TCI Compliance Interface Definition (Clause 169)

TCl Voltage / Current Interface for Clause 169

Until the January comment review cycle, TC3 was specified as the power interface (PI) for Clause 169 compliance.

169.4.3 MPSE TCI

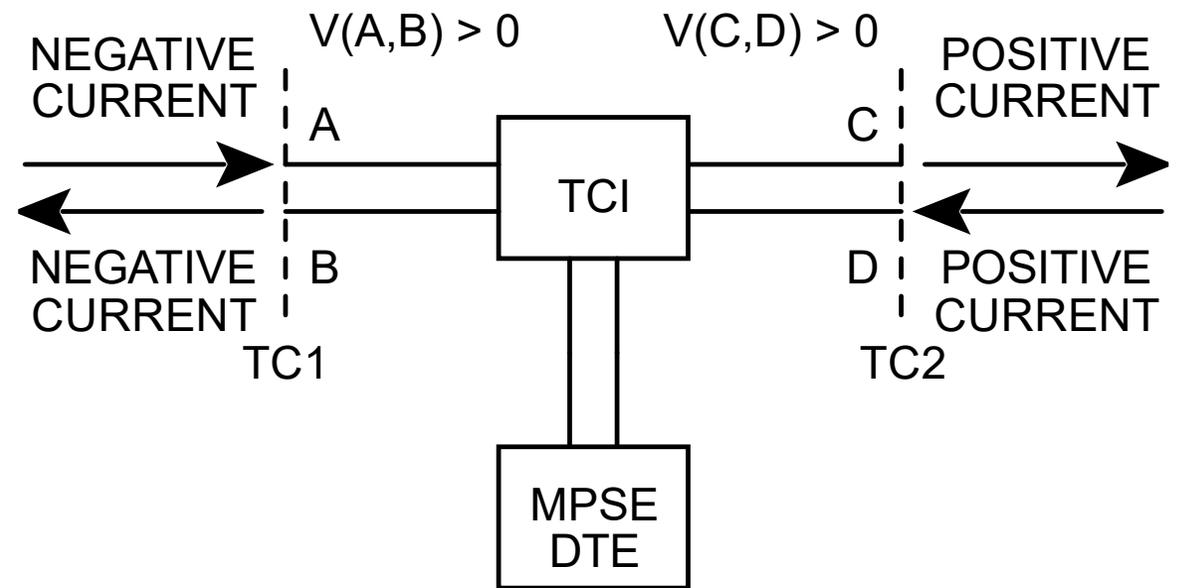
“MPSE TCI” text goes in after subsection 169.4.2

Change subsection 169.4.3 to 169.4.4

MPSEs supply power to the mixing segment.

Current at an MPSE TCI is defined as positive when current flows out of the higher voltage pin of the TC1 or TC2 interface and flows into the lower voltage pin of the same interface TC1 or TC2, respectively.

Current at an MPSE TCI is defined as negative when current flows into the higher voltage pin of the TC1 or TC2 interface and flows out of the lower voltage pin of the same interface TC1 or TC2, respectively.

For compliance, MPSE current is measured as the sum of TCI currents, TC1+TC2. Current shall be measured as the sum of both higher voltage pins on TC1 and TC2, or both lower voltage pins on TC1 and TC2.

For compliance, voltage specifications shall be met at both TC1 and TC2 independently.

“MPD TCI” goes in section 169.5.2

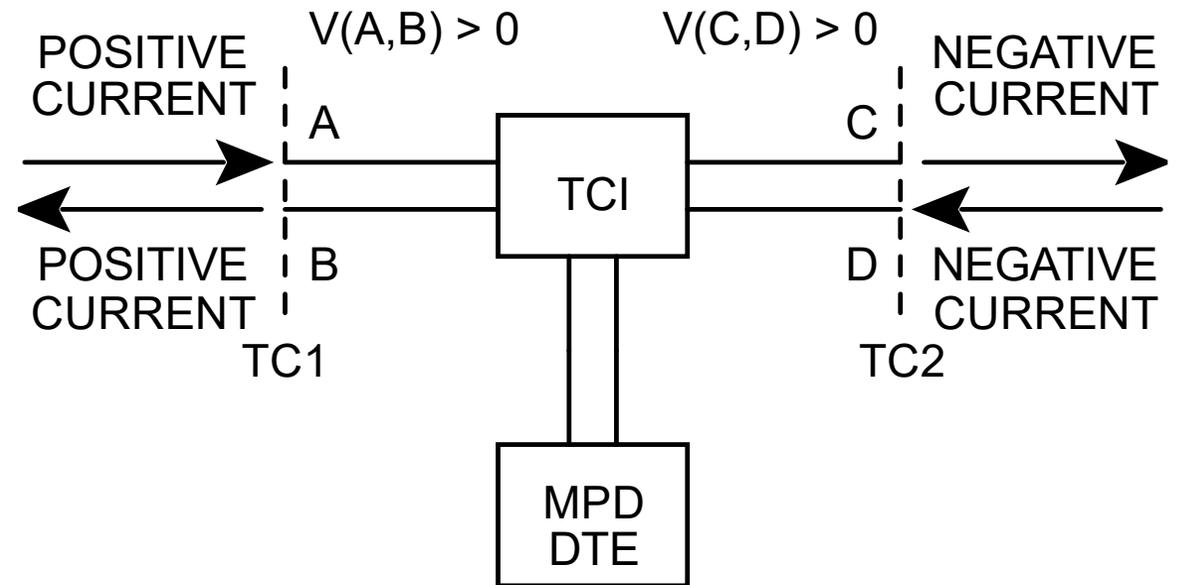
Insert Text after “Table 169-6–MPD pinout”:

MPDs draw power from the mixing segment. MPDs are current sinks.

Current at an MPD TCI is defined as positive when current flows into the higher voltage pin of the TC1 or TC2 interface and flows out of the lower voltage pin of the same interface TC1 or TC2, respectively.

Current at an MPD TCI is defined as negative when current flows out of the higher voltage pin of the TC1 or TC2 interface and flows into the lower voltage pin of the same interface TC1 or TC2, respectively.

For compliance, MPD current is measured as the sum of TCI currents, TC1+TC2. Current shall be measured as the sum of both higher voltage pins on TC1 and TC2, or both lower voltage pins on TC1 and TC2.

For compliance, voltage specifications shall be met at both TC1 and TC2 independently.
